Title: Permit 24-208: 20555 & 20565 Linden Road Project

Prepared by: Name: Veronica Sannes, Permitting Technician
Phone: 952-641-4580
vsannes@minnehahacreek.org

Summary:

Model Overview

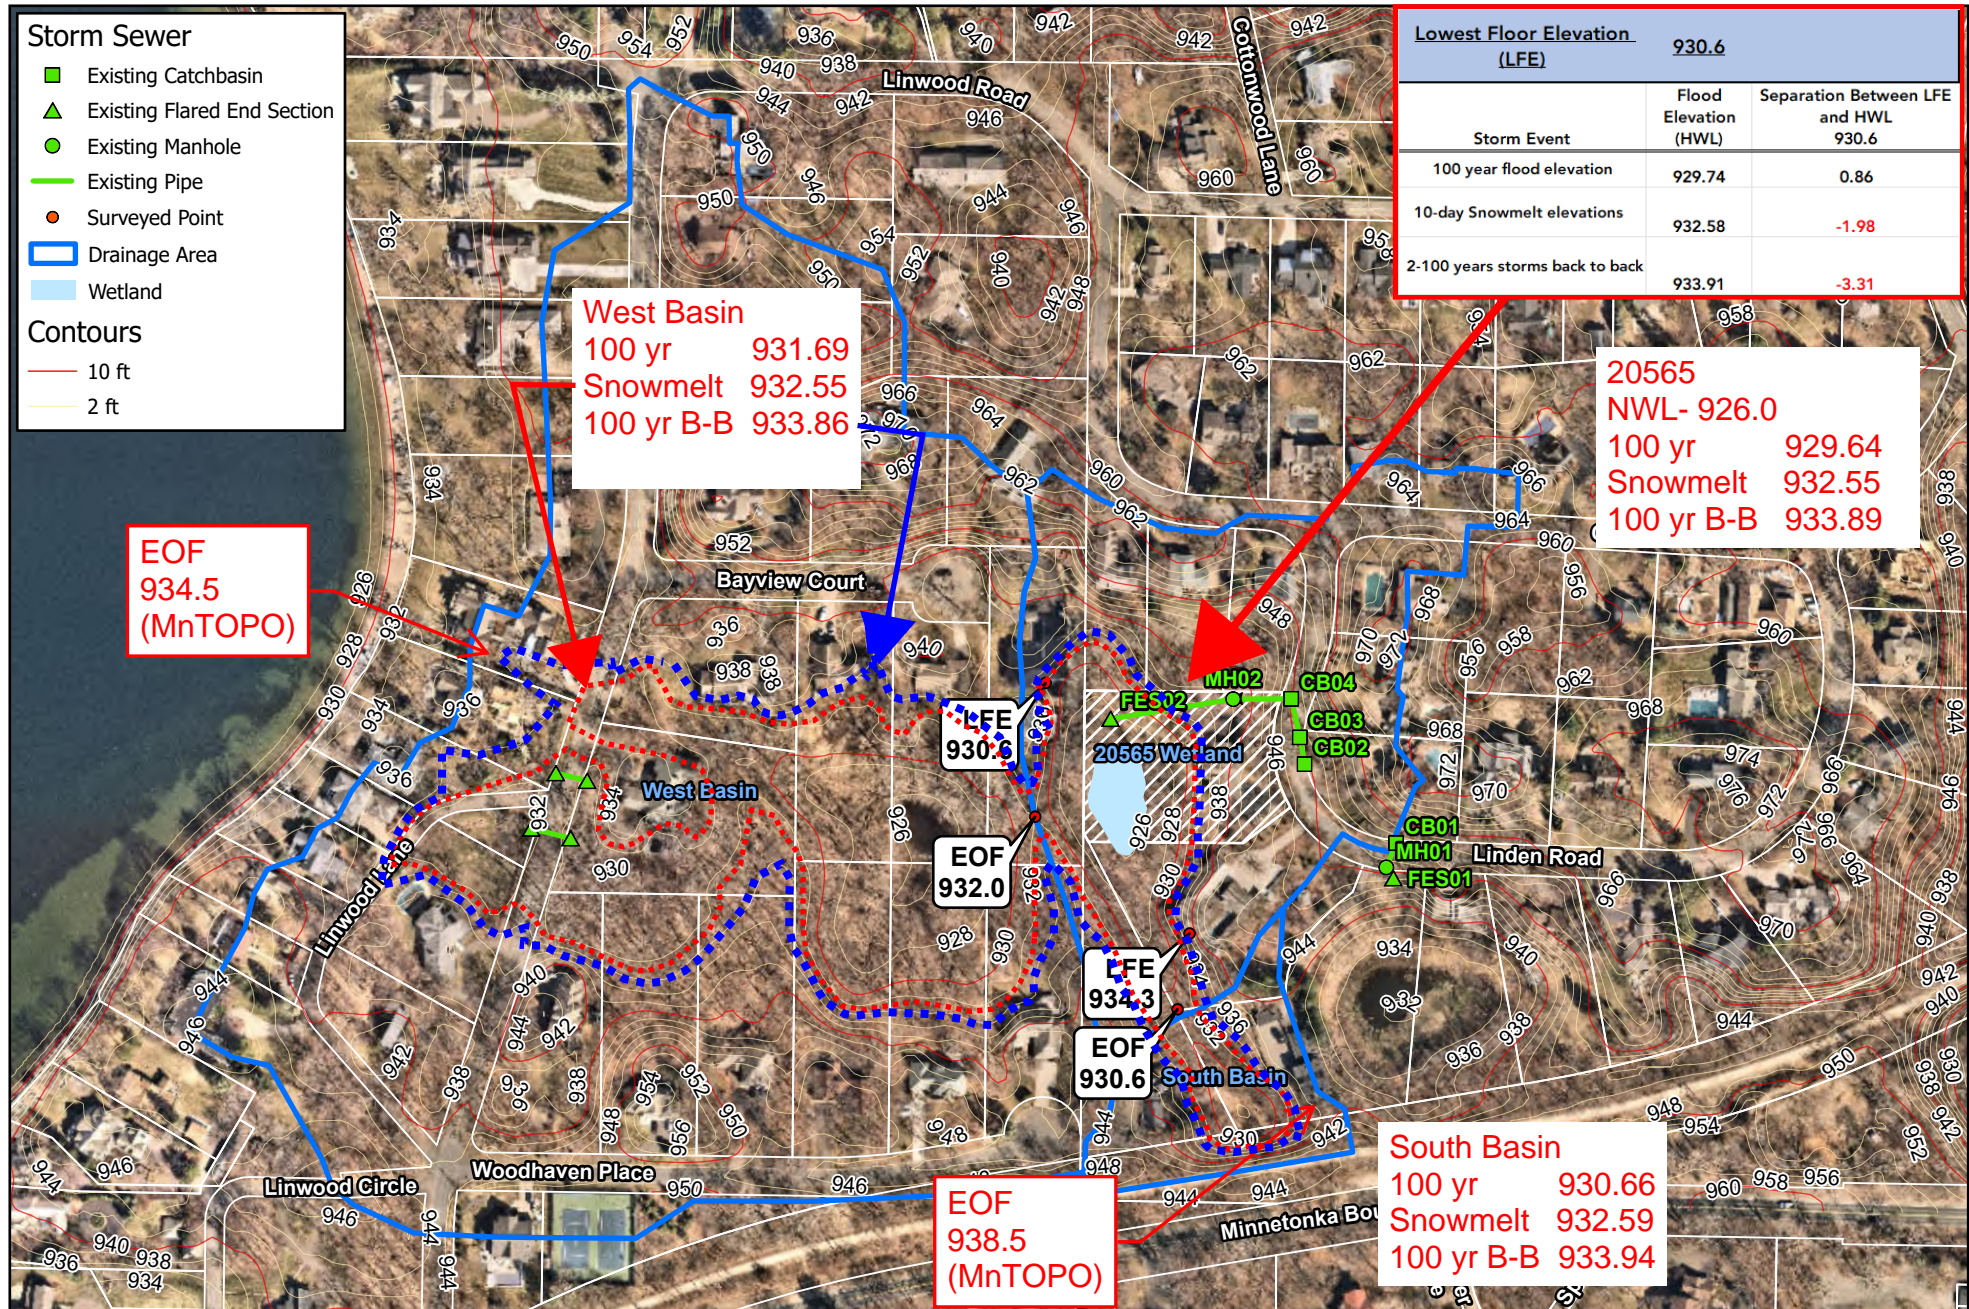
Loucks has reviewed the project for the Linden Road property and modeling associated therewith. Under certain flood events three landlocked wetland/basins will significantly flood the basement of one home and significantly impact backyards of numerous homes. The City's consultant hydrologist, WSB, has prepared a hydrology study on the impacts for various flooding events for the three landlocked basins. Because these three basins are landlocked with no emergency overflow elevation that is lower than the lowest house opening, WSB evaluated not only the 100-year 24 hour storm event, but also 10-day snowmelt and back to back 100 year events. See attached Model Overview map showing location of the three basins.

There is particular concern the landlocked basin at the rear lot of 20565 Linden Road identified on the Model Overview map as 20565 Basin. During our review it was determined that the 20565 Basin was not an isolated basin, but three basins were hydrologically connected. The three basins are not connected by piping, but the hydrologic modeling prepared by WSB showed that some of the rainfall events result in flood elevations overtopping natural spillways. The results of stormwater ponding overtopping spillway significantly raised the flood elevations of the 20565 Basin.

The critical issue is the home site at 20625 Bayview Court has the lowest basement elevation of the neighborhood. The hydrology model indicates that this home will flood the basement with over 3.3 feet of water with the larger storm events (see Table 1). Because the basin on the subject property has no storm outlet, any development of this site should address a potential stormwater outlet from this basin before any future development occurs.

- i) WSB hydrologically modeled three depressions, West Basin, 20565 Basin, and the South Basin as shown on the Model Overview Map. The hydrology modeled indicates that the two other basins (west and south) will overtop into the wetland on the Subject Property based on flood elevations and Emergency Overflow Elevations (EOF) identified in the field. The EOF on the south basin is approximately 938.5 per MnTOPO indicating there is no land from the south pond which drains to a low wetland area near Minnetonka Boulevard that also may be landlocked. The EOF on the west basin is approximately 934.5 per MnTOPO which would drain to Lake Minnetonka.

- i) As seen by Table 1 the modeling evaluating the three basins show that the 10-day snowmelt and two back to back 100 years storms will flood the basement of the 20625 Bayview Court.

- ii) Because the wetland/flood basin on the Subject Property has no positive outlet, the only way for the water to drawn down between events is mostly by infiltration into the soils. During snowmelt, the ground is frozen and will prevent infiltration. Also, spring rains, prior to the snowmelt, increase the runoff volumes that an basin which has no outlet will flood. When multiple large rainfall events occur within a few days of each other, the basins do not have enough time for reducing the volume of standing water from the first rainfall by infiltration into the soil. Therefore, the next rainfalls have to pond its water on top of the previous ponded area. Hence, the 2-100 year storm analysis predicts the outcome when multiple storms occur in a few days of occurrence.

- iii) Without clear understanding of the water infiltration rate into the underlying soil of 20565 Basin, it is hard to predict what the normal water level of the wetland would be prior to a 100-year event. If there are consecutive rainfalls or a prior rainfall that creates a pool of water 2.2 feet of standing water in the 20565 Basin to an elevation of 928.2, and then a 100-year flood occurs, the 100-year flood would rise to the 930.6 (the elevation of the lowest basement elevation). A better understanding of the normal water elevation prior to a potential 100-year flood should be determined.

- iv) The updated survey determined that the lowest elevation of the homes directly adjacent to wetland basin is 20625 Bayview Court (home on end of cul-de-sac). The walkout basement elevation is 930.6.

- (1) The home elevation is 0.86 feet **above** the existing 100-year flood elevation assuming there is no water standing in the bottom of 20565 Basin prior to the 100-year storm occurring. If there is 2.2 feet of water standing in prior to a 100-year event, the 100-year flood will be at the lowest floor elevation of home 20625 Bayview Court.
- (2) The 10-day Snowmelt will flood the home by almost two (2) feet.
- (3) Two (2) 100-year back to back storms will flood the home by 3.3 feet.

The property owners of 20652 Bayview Court, through their attorney Larkin Hoffman, express a concern about increased flood risk to homes and backyards as a result of the Project. The concern rests on a report prepared by their consultant, Loucks Inc. Due to a walkout basement elevation of 930.6 feet, the property would be flooded by 1.96 feet in the event of a 10-day snowmelt and by 3.29 feet in the event of two back-to-back 100-year storm events. The proposed 100-year high water elevation is 929.64 feet, which is below the 20652 Bayview Court lowest floor elevation of 930.6 feet by just under one foot and is a slight reduction of the existing 100-year elevation.

The MCWD Stormwater Management Rule doesn't apply to this application, and the flood elevation criteria of the MCWD floodplain alteration rule apply only to new structures, not existing structures. That said, modeling by the City of Deephaven indicates that despite the increase in impervious surface from the construction of the additional home, the Project's increased floodplain storage will maintain or decrease floodplain elevations for all analyzed precipitation events. For the 1-year storm event, the proposed high water level elevation is 927.13 feet, over 3 feet lower than the basement walkout elevation at 20652 Bayview Court. While concerns about flood risk are acknowledged, they fall outside the scope of MCWD rules and the modeling done by the City of Deephaven indicates that the Project would slightly reduce the flood risk for 20652 Bayview Court.

Hydrologic and Hydraulic modeling of this nature is not intended to calculate the absolute value of localized water elevations, but instead is intended to be used to understand relative changes between the existing and proposed condition. The modeling completed by the City/WSB in May of 2023 was based on a previous iteration of the development plans for the subdivision (dated February 2023), which presumably is the reason why the modeling accounts for 1,767 square feet more impervious surface than is depicted on the current version of the plans. Furthermore, the modeling completed by the City assumes the proposed earthwork on the site will result in 5,525 cubic feet of increased floodplain storage between elevations 926.0 feet and 929.72 feet, which is less than the floodplain storage creation indicated on the current site plans (6,256 cubic feet). Therefore, the resulting relative differences in water levels of the wetland resulting from the City's modeling are considered to be conservatively high. Summaries prepared by the City reference slightly different high water level elevations than are contained in the reviewed modeling, though the net difference in water level elevations between existing and proposed conditions follow similar trends in that the proposed condition levels are less than existing conditions levels for all analyzed events except the 1-year.
